Well Name: OLIVE WON UNIT	Well Location: T22S / R31E / SEC 25 / SESE / 32.3569834 / -103.7268394	County or Parish/State: EDDY / NM
Well Number: 173H	Type of Well: OIL WELL	Allottee or Tribe Name:
Lease Number: NMNM25365	Unit or CA Name:	Unit or CA Number:
US Well Number: 3001554655	Operator: OXY USA INCORPORATED

Sundry ID: 2834007

Type of Submission: Notice of Intent	Type of Action: APD Change
Date Sundry Submitted: 01/27/2025	Time Sundry Submitted: 01:10
Date proposed operation will begin: 02/10/2025

OXY USA Inc. respectfully requests to amend the subject AAPD to update the well name, SHL, BHL, HSU and drill plan w/ blanket design A.

### 6. Wellbore Diagram(s)

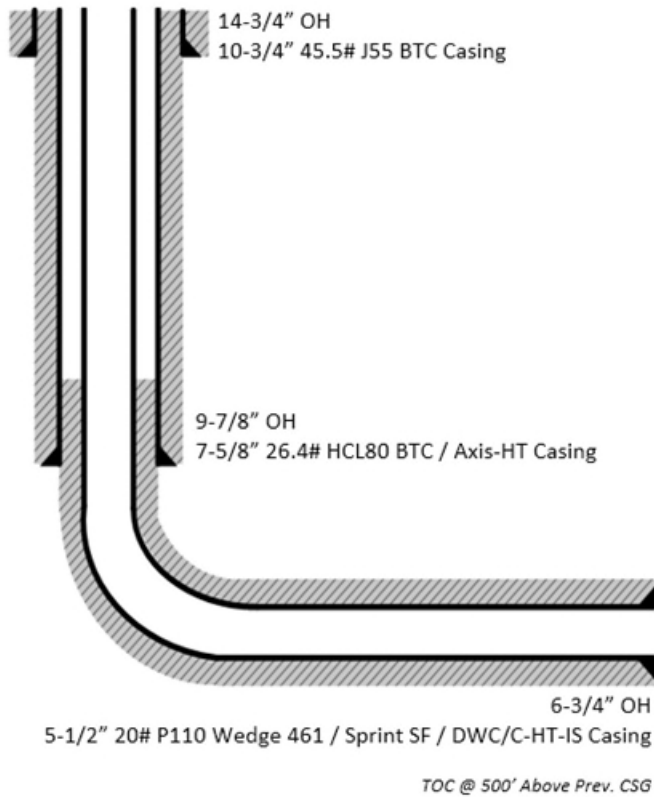
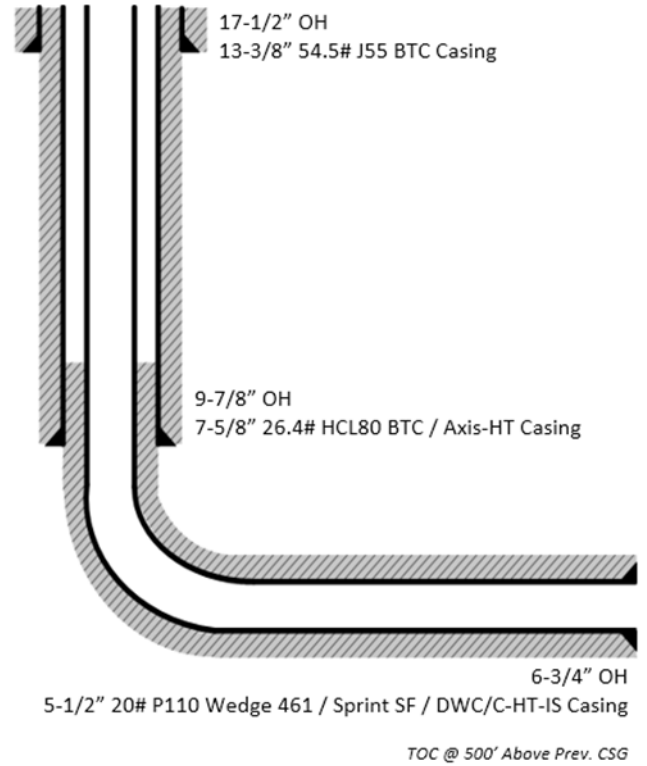
**NOTE: WELL APPROVED FOR DESIGNS A1 AND A2. REVIEW CEMENT VOLUMES TO ACHIEVE TIE BACKS LISTED BELOW.**

\*FTP TO LTP LINE BEARINGS

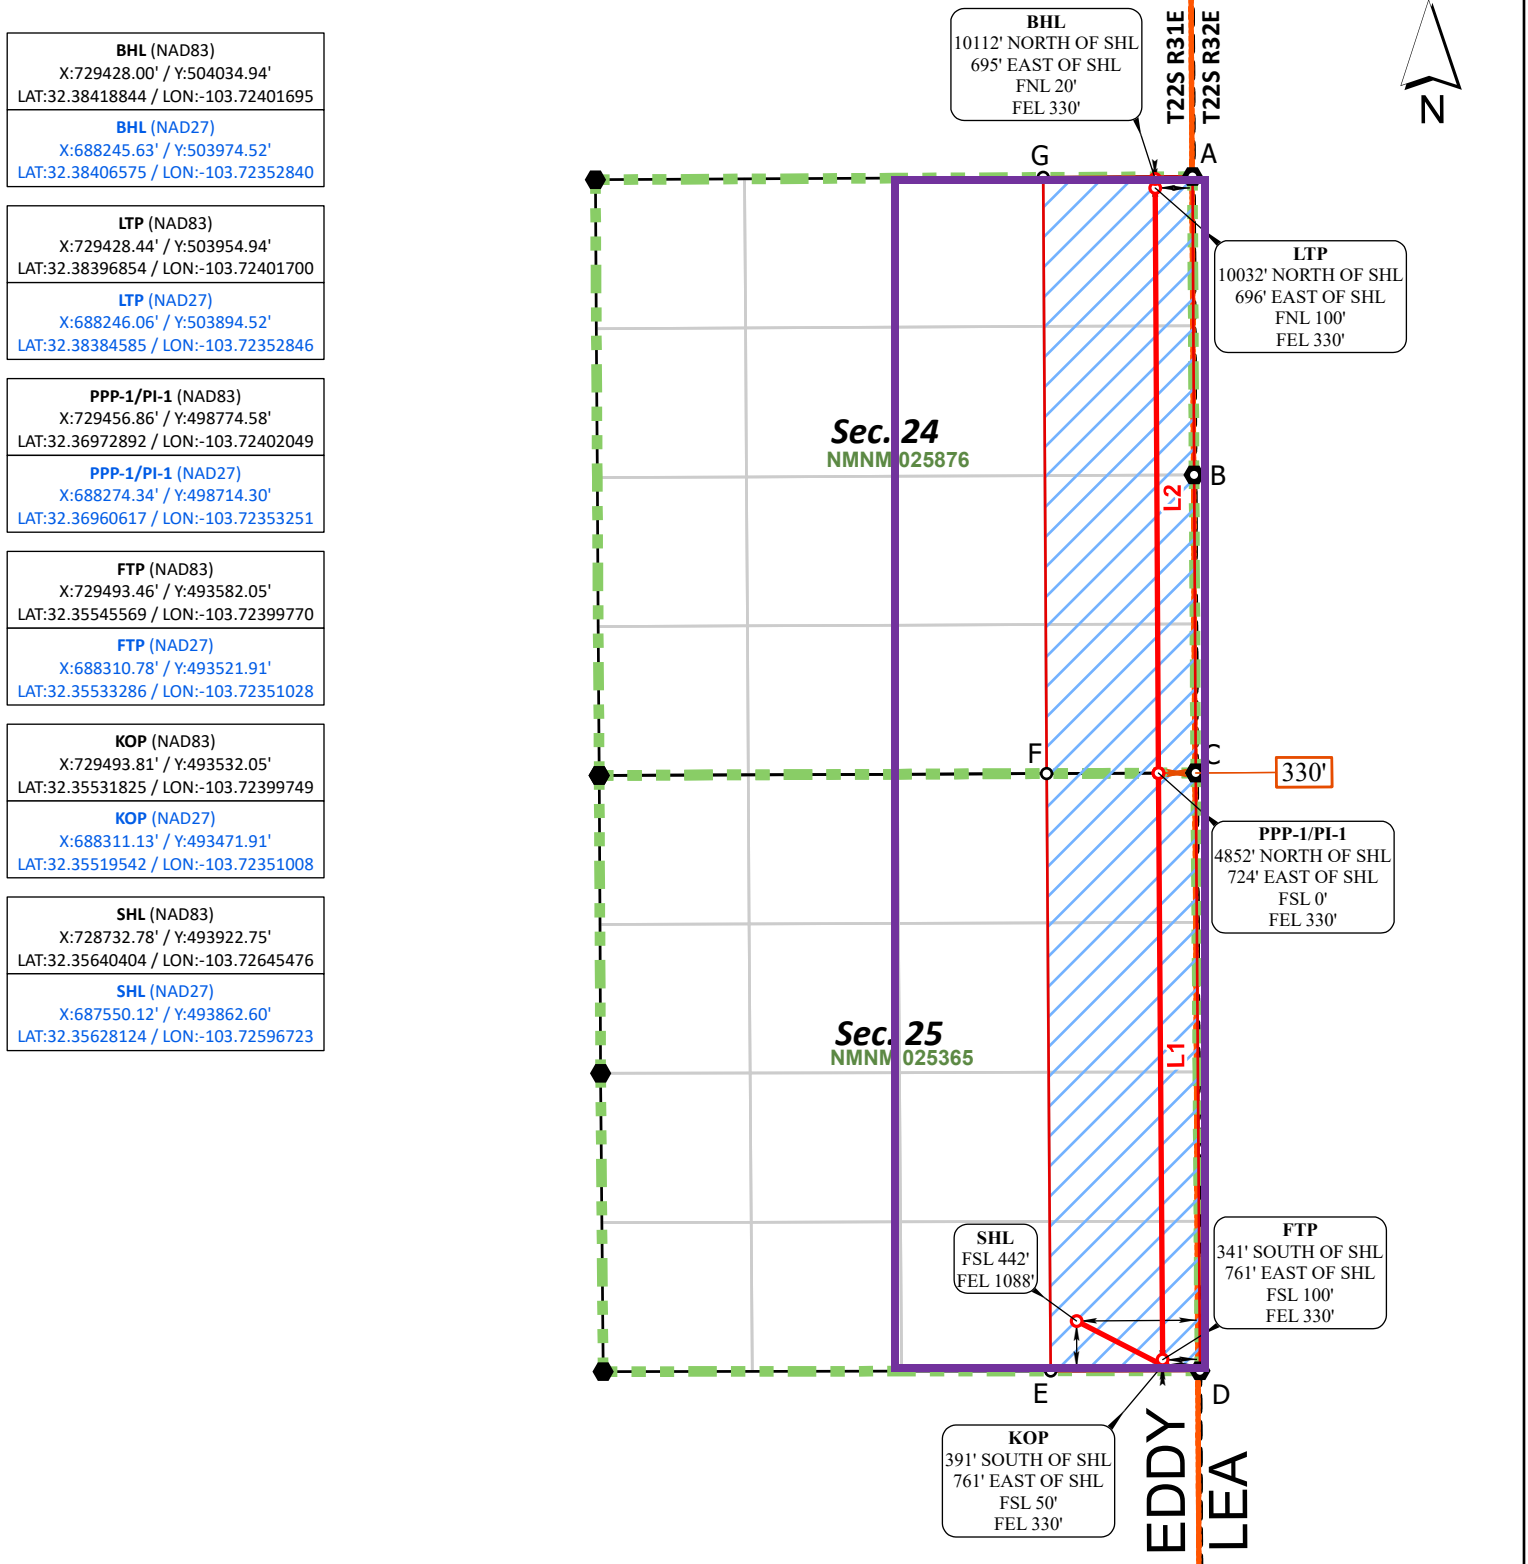
Current SHL: 652' FSL 1207' FEL

New SHL: 442' FSL 1088' FEL

Current BHL: 20' FNL 390' FEL

New BHL: 20' FNL 330' FEL
